NOTICE OF ADDENDUM

Addendum No.: 2

Procurement Name: Construction Services for the Lakeview Golf Course Maintenance Building Redevelopment

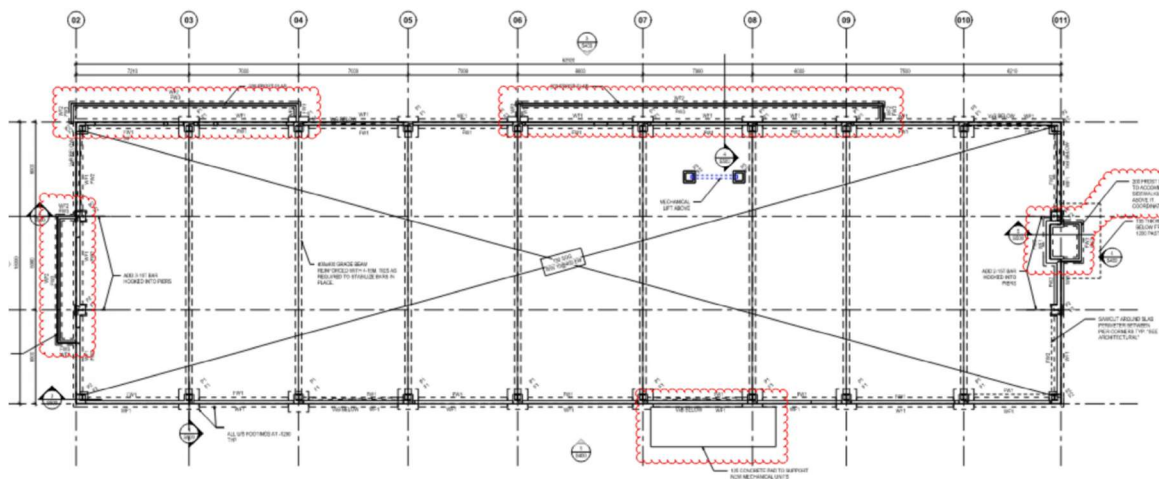
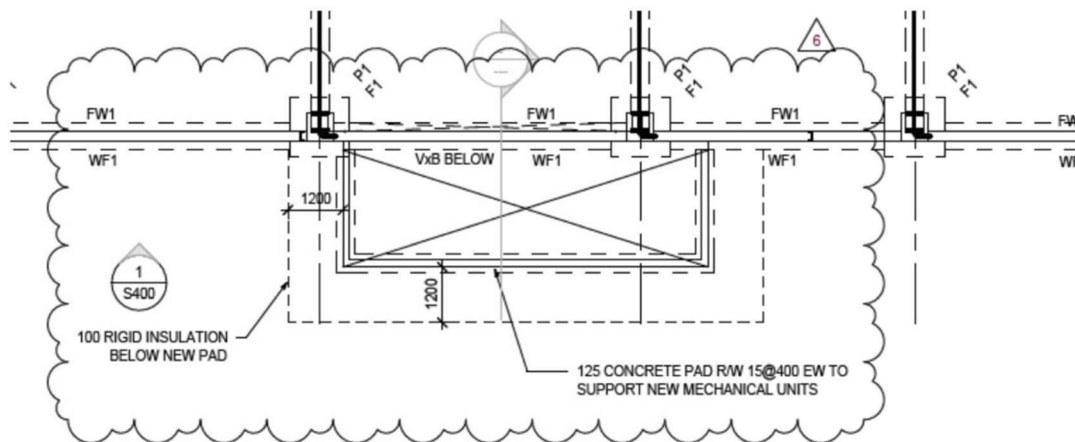
See below clips(as clouded). Are there any rebar in the frost slab and Concrete pad? There's nothing shown on the section. Please confirm.

Please refer to Structural Addendum #1
